# BCDC Committee

27 March 2018

## 1550 Soldiers Field Road & 21 Soldiers Field Place

Harvard  
Business  
School

### Alternate Soldiers Field Road Streetscape

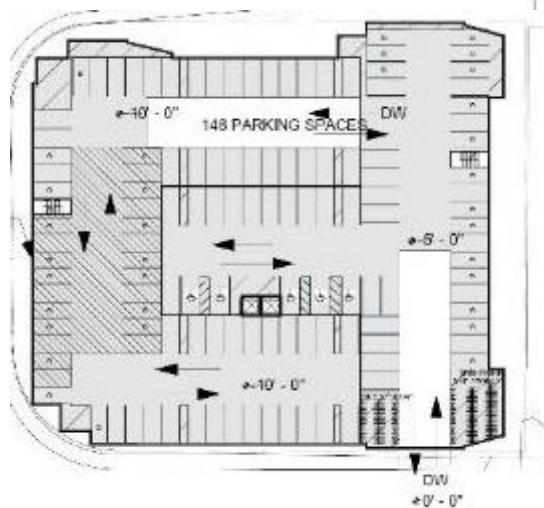
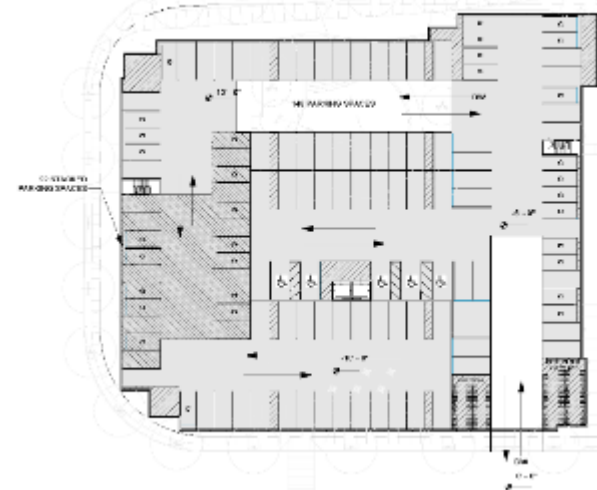
### 3/6/18 BCDC Site Comments:

- The building looks too tight to Soldiers Field Road – need to step the building back.
- The garden is clever with the berming.
- Entry courtyard works really well.
- Create a more pedestrian-friendly experience along Soldiers Field Road.
- Should open space be increased on the south side?
- Describe streetscape.

### Project Revisions:

- Pulled back the building from Soldiers Field Road.
- Created a 'Complete Streets' condition on Soldiers Field Road/Place.
- Added street trees and buffer trees to improve views from units.
